Council's previous submissions on this development raised concerns regarding the long term impacts of the carparking solutions for this development. In particular the provision of above-ground parking, surface and multi-storey, to the north of the site on prime potential recreation grounds that are adjoining and upland of bushland and riparian areas, and visible from the residential areas across the valley.

3) A minor alteration to the approved location and internal flow of the multi-deck carpark (bringing the structure closer to the hospital wings and allowing pedestrian access at the one level); and

**PLEASE REFER TO ATTACHMENTS 1,2,3,4,5 – mark ups of drawings**

**Table 1 – Alterations to Levels of the Modified Multi-Deck carpark**

073

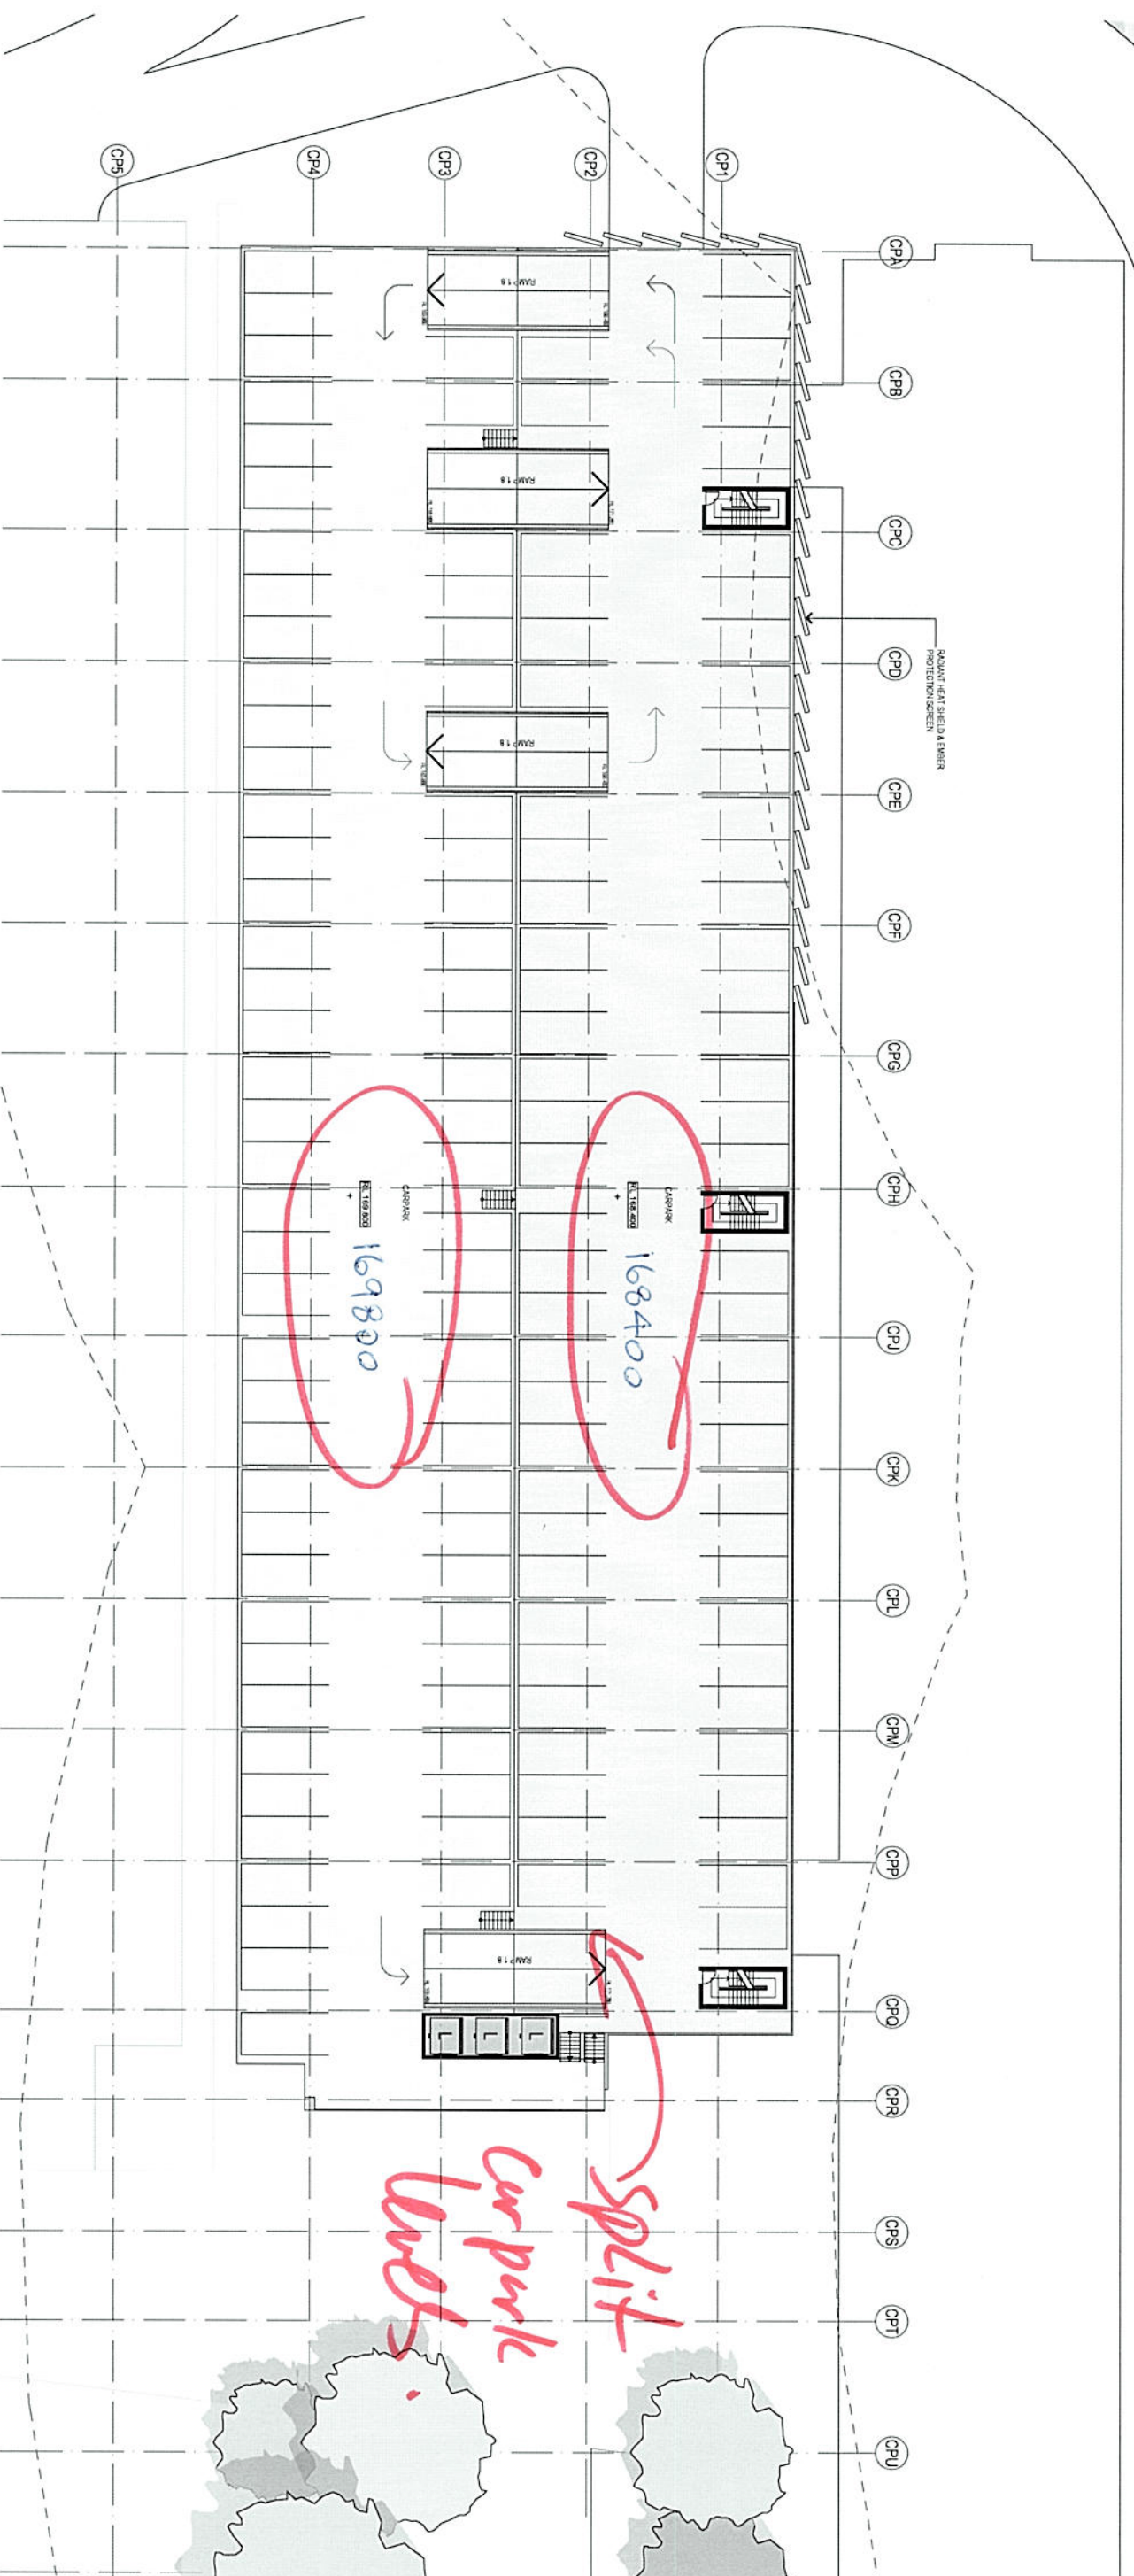
Walking / pergoes to hospital but they have been removed.

Entry - is now joined to Carpal experience.

**MULTI-DECK CARPARK**  
Floor Plan Level 4  
1:200 @ A1  
14/07/2010  
AEA-014  
A

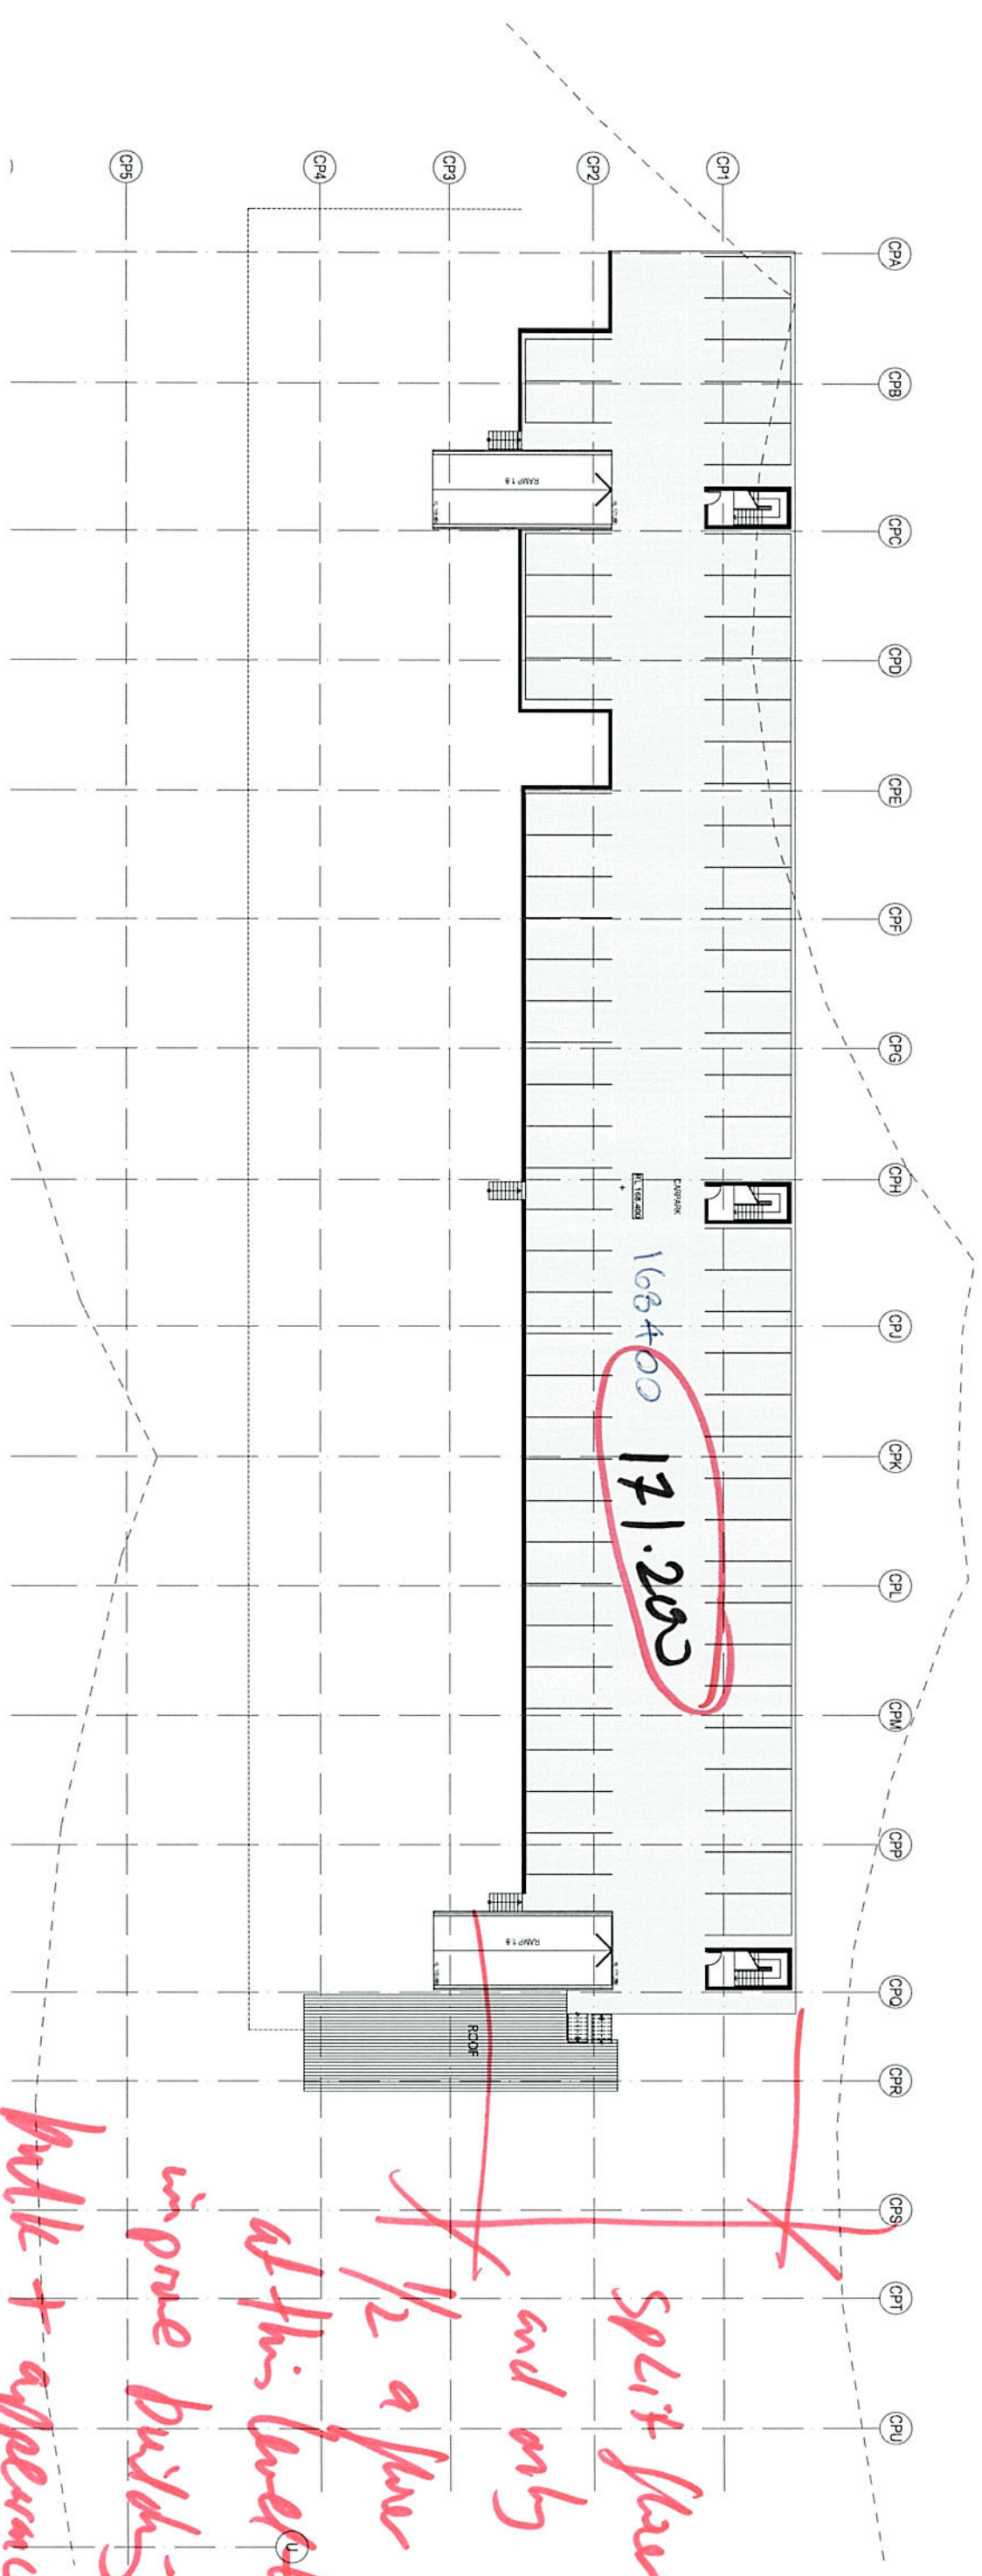
Split floor  
and only  
1/2 a floor  
at this level to  
improve building's  
built + appearance  
and reduce impact.

Modified - LV1.5

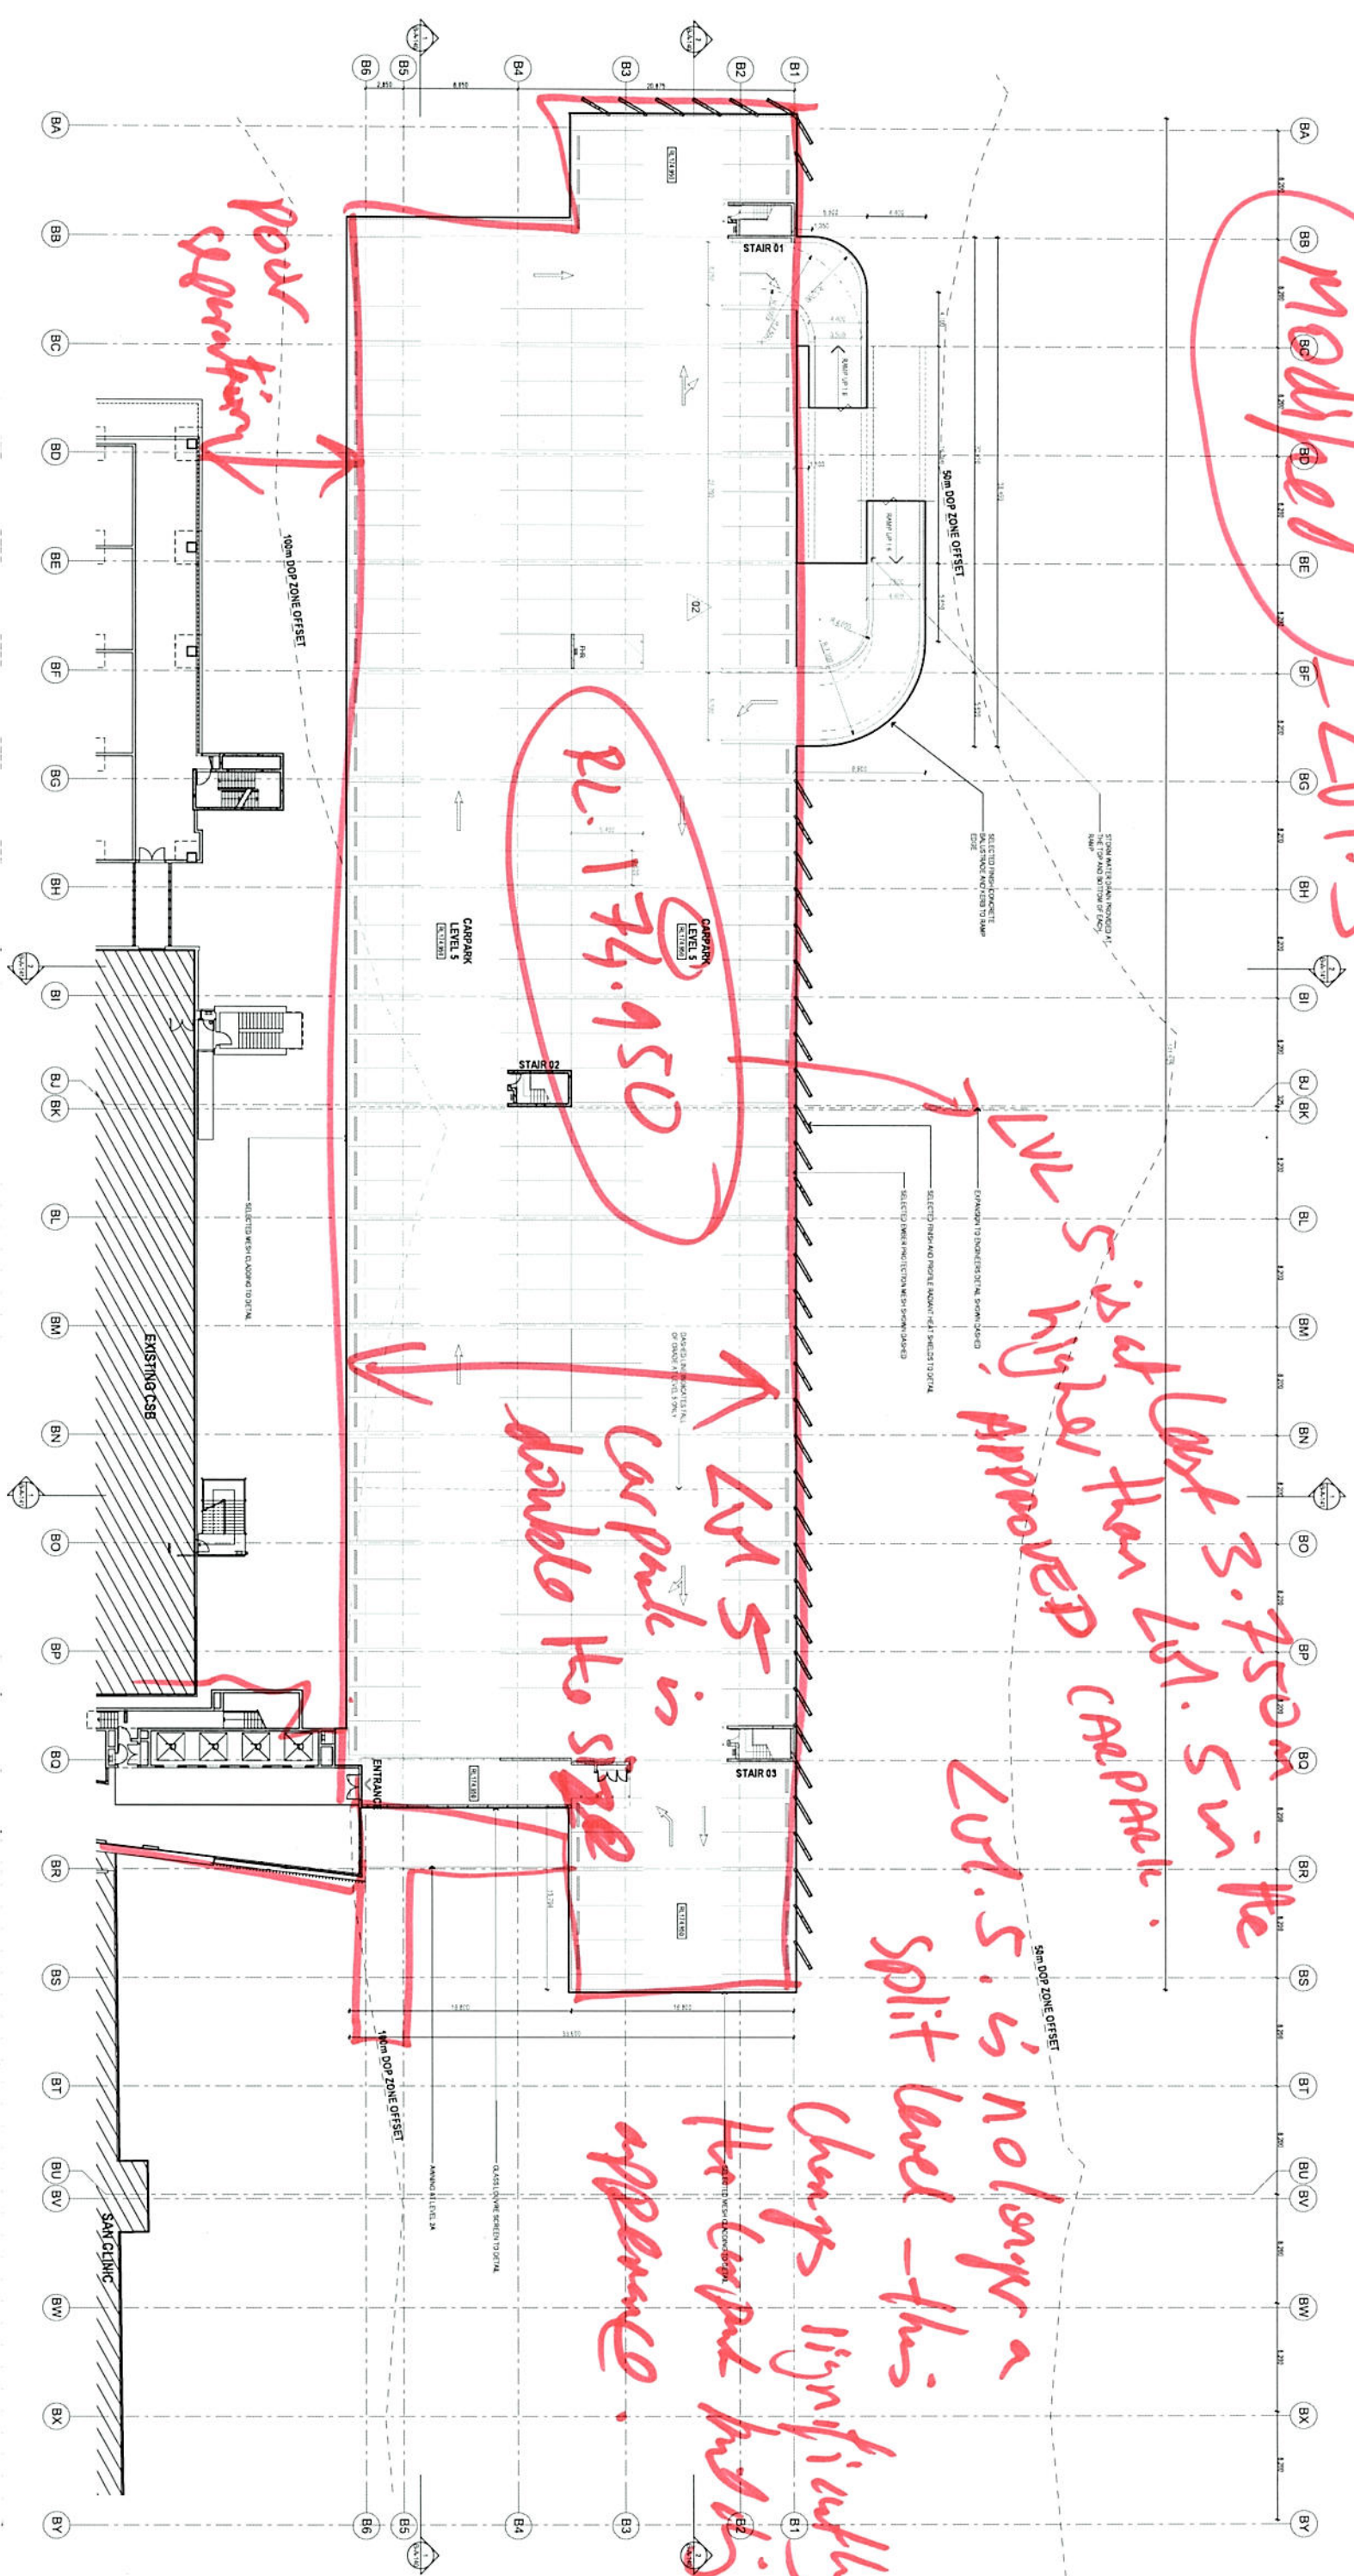
LV 5 is at least 3.750m in the side from LV1.5 in the approved carpark.

LV1.5 is no longer a split level - this changes significantly the carpark building's appearance.

carpark is double the size
